| APPLICATION NO. | FILING DATE | FIRST NAMED INVENTOR | ATTORNEY DOCKET NO. | CONFIRMATION NO. |
|--|-------------|----------------------|---------------------|------------------|
| 10/634,287 | 08/05/2003 | Timothy W. Crockett | RPS9-2002-0138US1 | 7985 |

Office Action Summary

DETAILED ACTION

Replacement Sheet
 Title: **KEY CODE FILTER APPARATUS AND METHOD**
 Inventors: Crockett et al.
 Docket No.: 1300.2.16 / RPS9-2002-0138 (JBS)
 Page 1 of 8

Fig. 1A

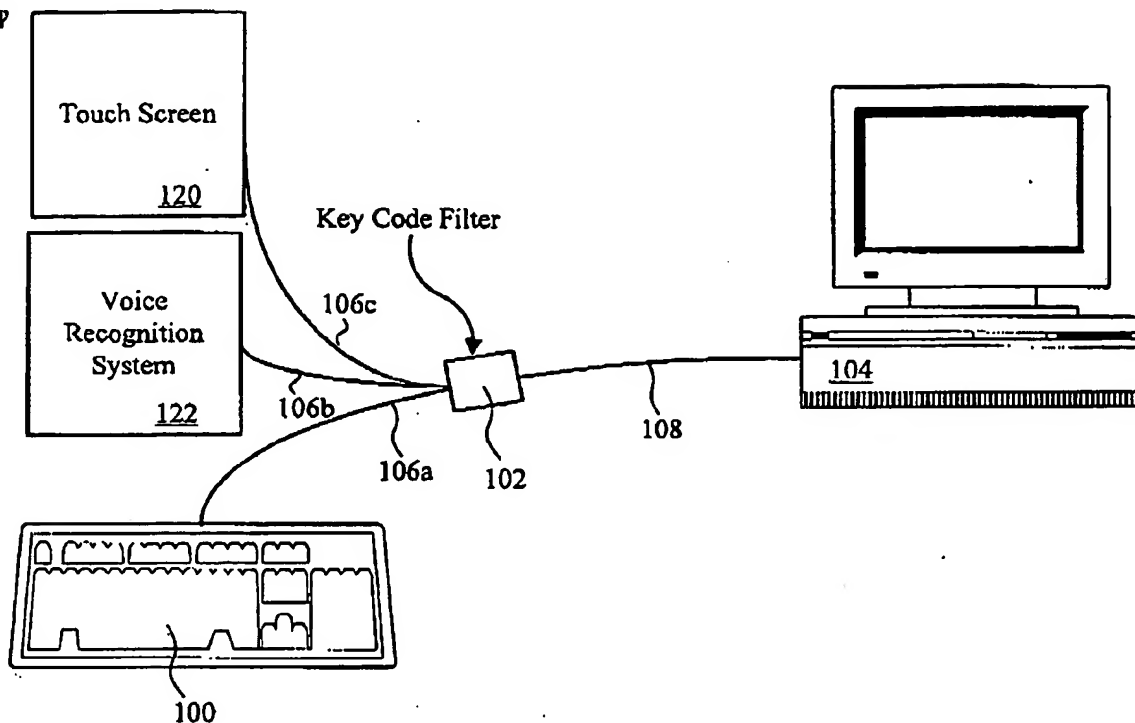
4. The drawing was received on 01/04/2006. This drawing is disapproved because it introduces new matter into the disclosure. The original disclosure does not disclose the key code Filter 102 simultaneously connected to a keyboard 100, a touch screen 120, a voice recognition system 122, and a host computer 104, as shown in the submitted drawing.

NOT APPROVED

Fig. 1B

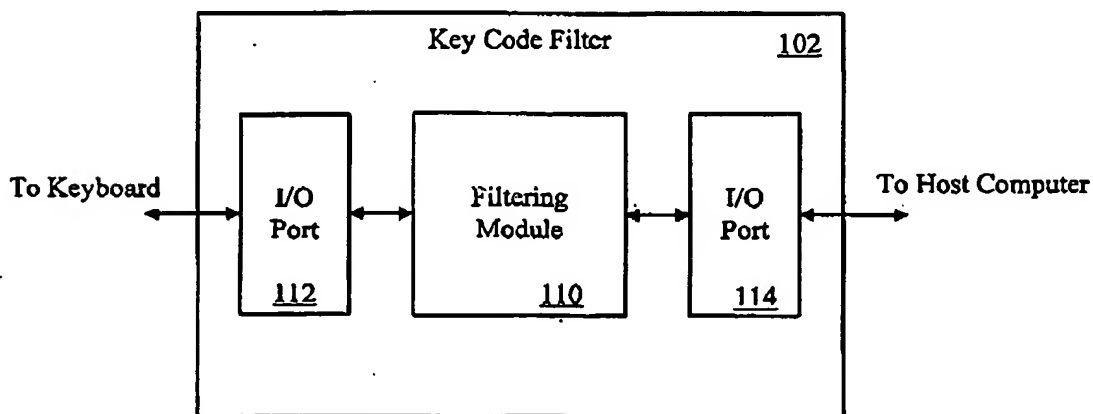
5. The drawings are objected to because "Filtering Module 110" as shown in Fig. 1B and "Filter Module 300" as shown in Fig. 3 are clearly distinct from each other, but are named

similarly. Further, as noting in Figs. 1B, 2 and 3, the Filtering Module 10 is a hardware and comprises elements (210, 216, 222, 224 and 226) (see Fig. 2) including a memory 216 which includes a Filter Module 300 (see Fig. 3). Also, a Filter Module 300 of the memory is not a hardware and a merely virtual portion of the memory and a module is usually referred as a packaged functional assembly of electronics components for use with other such assemblies (see Merriam Webster's Collegiate Dictionary, tenth edition). Therefore, it is suggested a Filter Module 300 should be named differently from the Filtering Module 100, e.g., Filtering Code, Filtering Subroutine, or etc..

17. Claims 1-11 recite the limitation "the unblocked key codes" in last line of independent claim 1. There is insufficient antecedent basis for this limitation in the claim. Additionally, it is not clear the claimed limitation, "a filtering module" recited in line 5 of independent claim 1, corresponding to a Filter Module 100 as shown in Fig. 1B or a Filter Module 300 as shown in Fig. 3.
